Council Reference: DA18/0685 LN40120  
Your Reference: SSD 9575

**State Significant Development SSD 9575 (Council Reference DA18/0685) - Concept Application, Stage 1 works and SEPP to Amend Tweed LEP 2014 for new Tweed Valley Hospital (NSW Planning & Environment App No. SSD 9575) at Lot 11 DP 1246853; No. 771 Cudgen Road CUDGEN**

**Annexure 1**  
**MATTERS FOR CONSIDERATION BY THE DETERMINING AUTHORITY**

*Stage 1 Works*

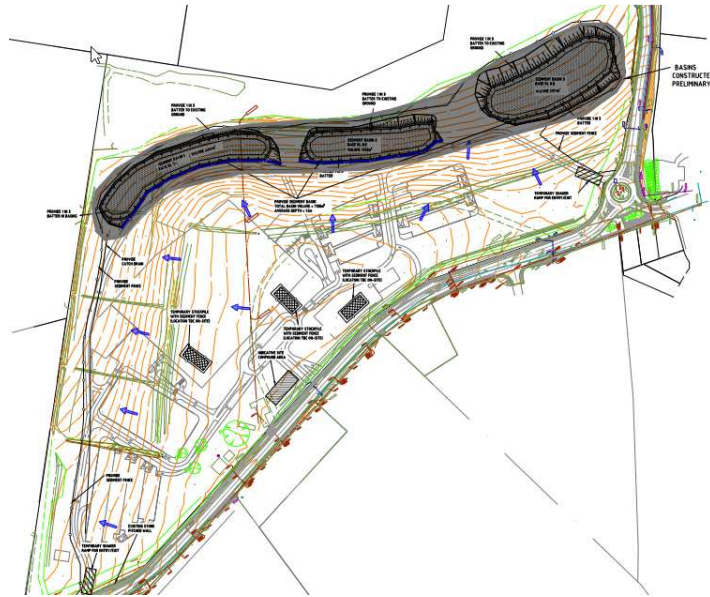
Section 4.5 of the Civil and Structural Design Report outlines the applicant strategy for soil and water management during construction. Key to the strategy are 3 x large sediment basins located towards the north of the site. The report states that: The design of these measures is in accordance with the Landcom “Blue Book”. Refer to drawings C0005, C0006 and C0007 for the Soil and Water Management plan, Typical Detailing and sediment basin volume calculation sheets. However, drawings C0006 and C0007 are not included in the appendices, nor are any sediment basin calculation sheets.

Whilst the proposed erosion and sediment control strategy is acceptable, little detail of the proposed measures is provided. For example, no details of the basin sizing calculations and basin outlet configurations are provided.

The early establishment stormwater works and erosion and sediment control strategy outlined can generally be supported in principle. However, further detail design documentation of the proposed works would usually be required to confirm the acceptability of detailed design. It appears that this opportunity will not be available under the proposed approval pathway.
